REVISED SITE PLAN
ROOF PLAN

B1 DEVELOPMENT, PEARTREE FARM

08/603/25a

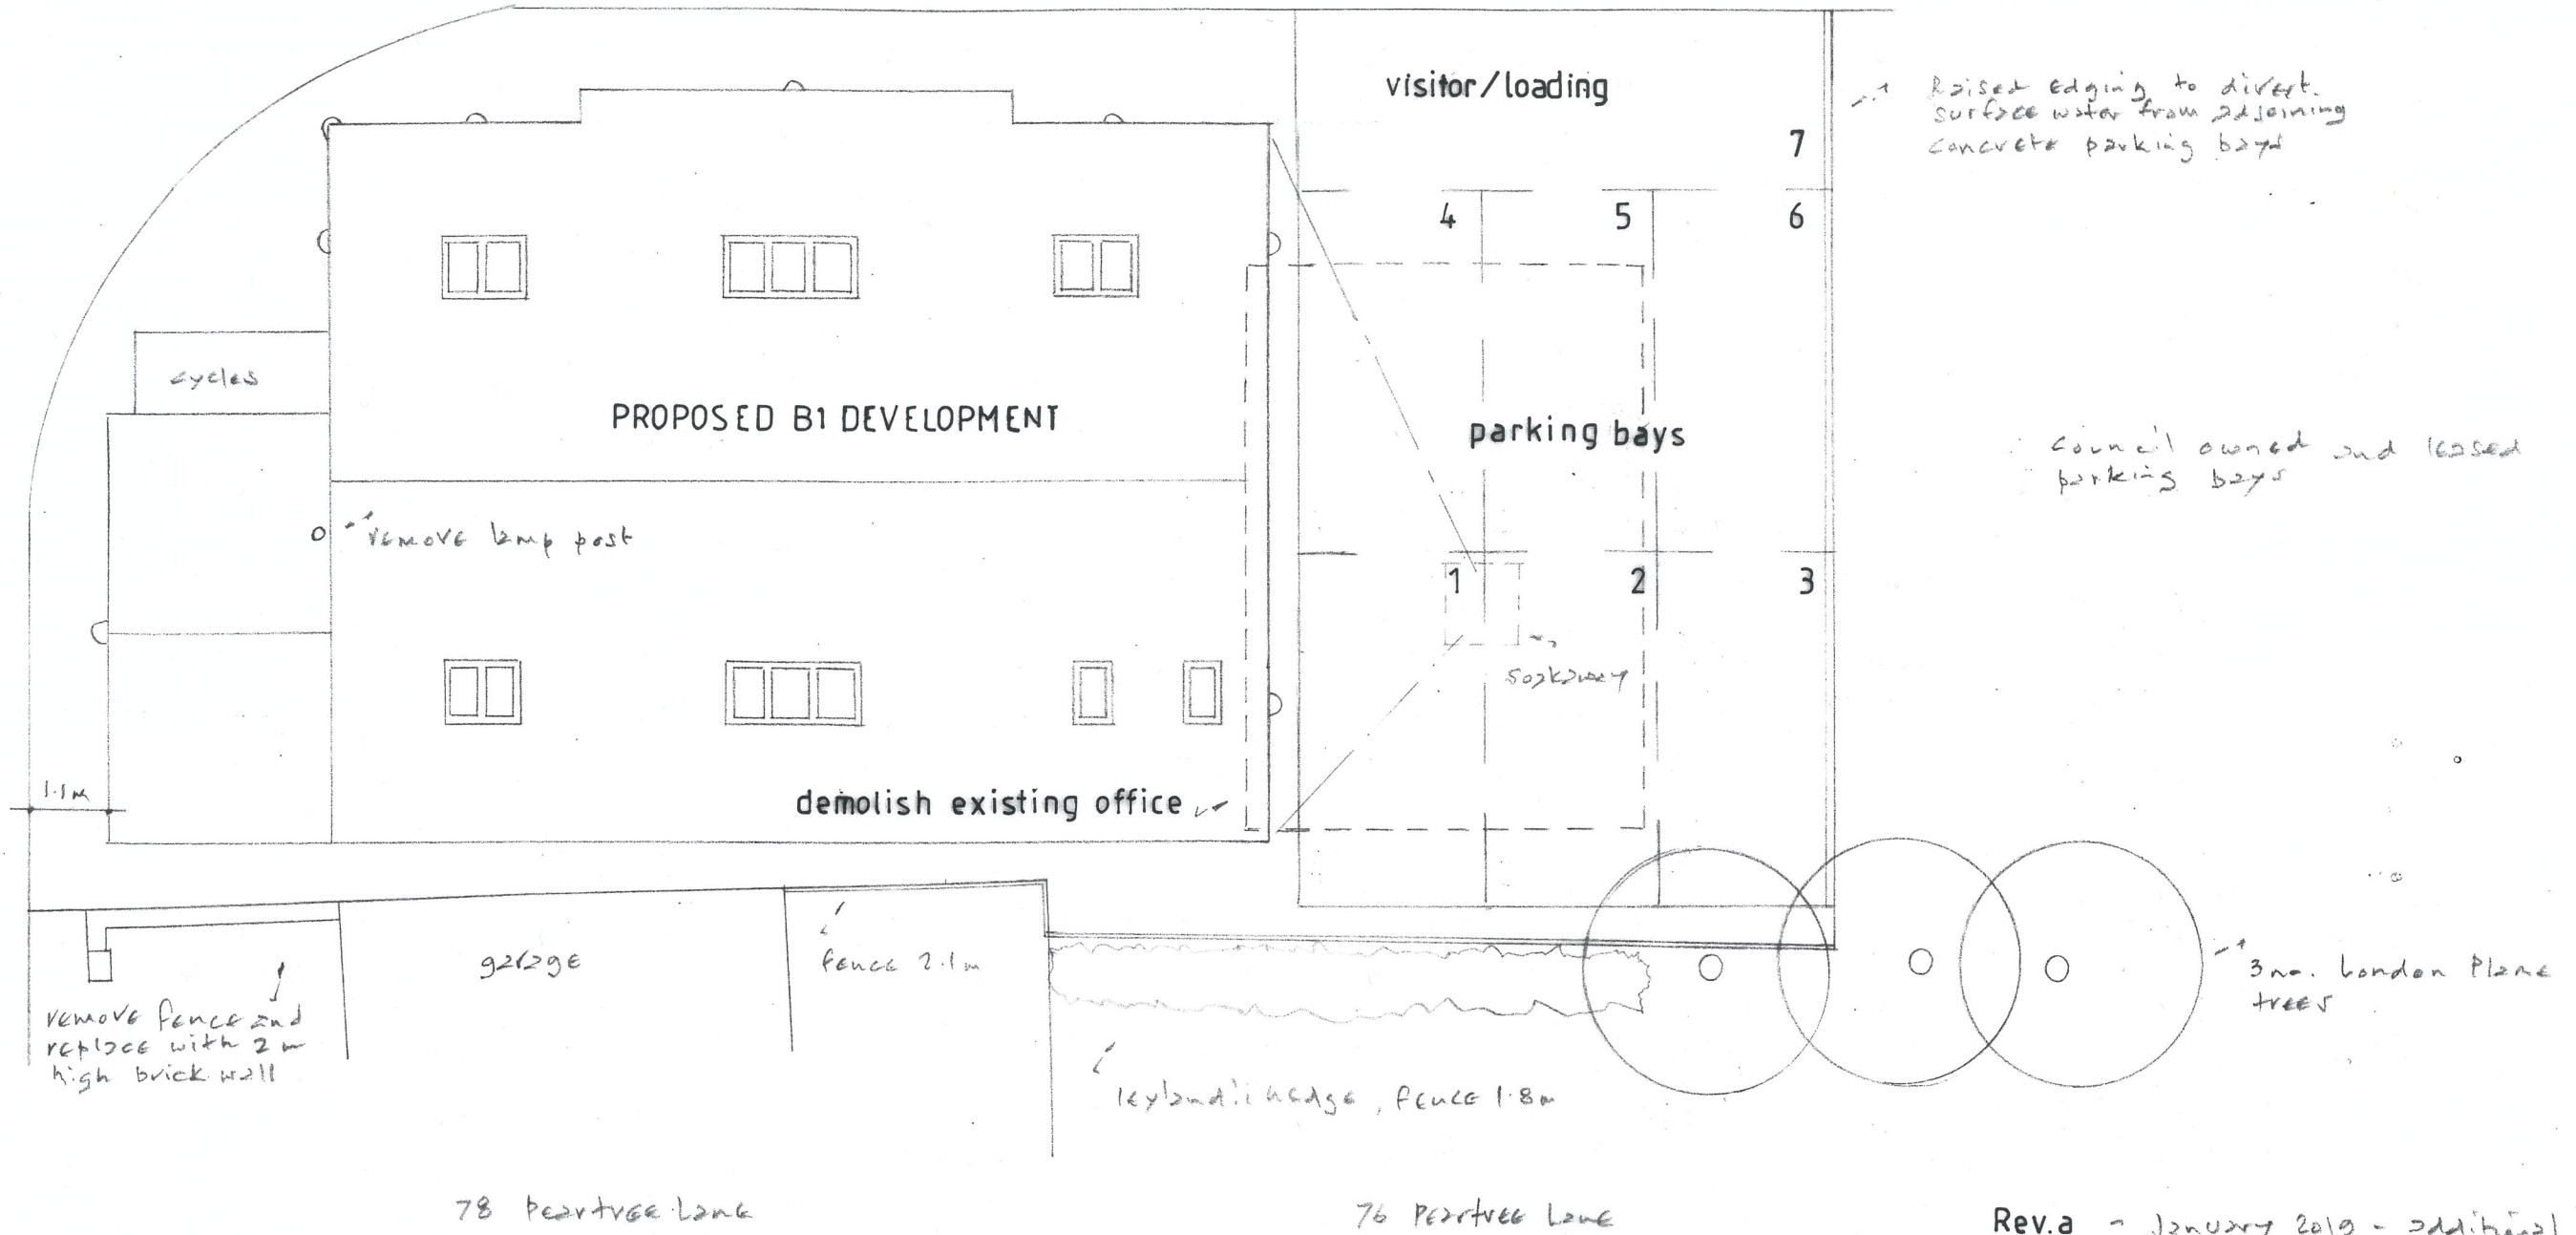
Rev.a - January 2019 - additional parking bays added, building repositioned, additional notes added.
